From: Gavrilas, Mirela
Sent: Thursday, June 16, 2016 5:57 PM
To: Mark Leyse
Cc: Lund, Louise; Khanna, Meena; Doyle, Daniel; Burnell, Scott; Bladey, Cindy
Subject: Re: Status of PRM-50-93/95

Information that Mr. Mohseni Disclosed (on November 24, 2015) on the TRACE Simulations of FLECHT 9573:

II. FLECHT Run 9573—a Comparison between the TRACE Predictions and the Results Westinghouse Reported

Figure 1. Section of the FLECHT Run 9573 Test Bundle that Incurred Runaway Oxidation

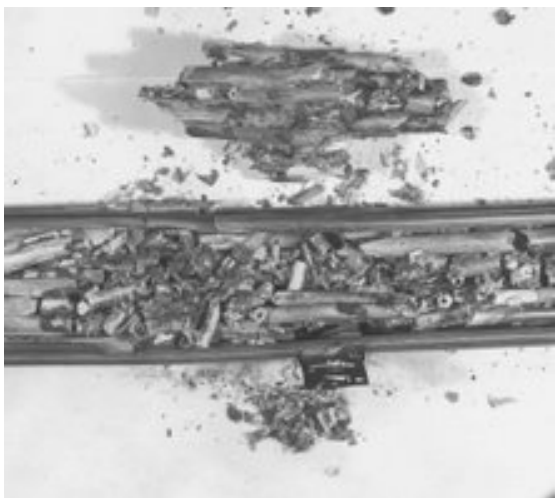
Westinghouse's "PWR FLECHT (Full Length Emergency Cooling Heat Transfer) Final Report" (hereinafter: "WCAP-7665") states that, "[t]he objective of the PWR FLECHT...test program was to obtain experimental reflooding heat transfer data under simulated loss-of-coolant accident conditions for use in evaluating the heat transfer capabilities of PWR emergency core cooling systems." [1] The FLECHT tests were conducted with bundles of heater rods sheathed in zirconium alloy (Zircaloy) cladding. Runaway oxidation was not expected to occur in any of the tests; however, the FLECHT Run 9573 test bundle incurred runaway oxidation (see Figure 1).

The FLECHT Run 9573 test bundle incurred runaway oxidation around its seven foot elevation. WCAP-7665 states: "Post-test bundle inspection indicated a locally severe damage zone within approximately ± 8 inches of a Zircaloy grid at the 7 ft elevation. The heater rod failures were apparently caused by localized temperatures in excess of 2500°F." WCAP-7665 also states: "During the test, heater element failures started at 18.2 seconds... At the time of the initial failures, midplane [at the 6 foot elevation] clad temperatures were in the range of 2200-

2300°F. The only prior indication of excessive temperatures was provided by the 7 ft steam probe, which exceeded 2500°F at 16 seconds (2 seconds prior to start of heater element failure).”[2]
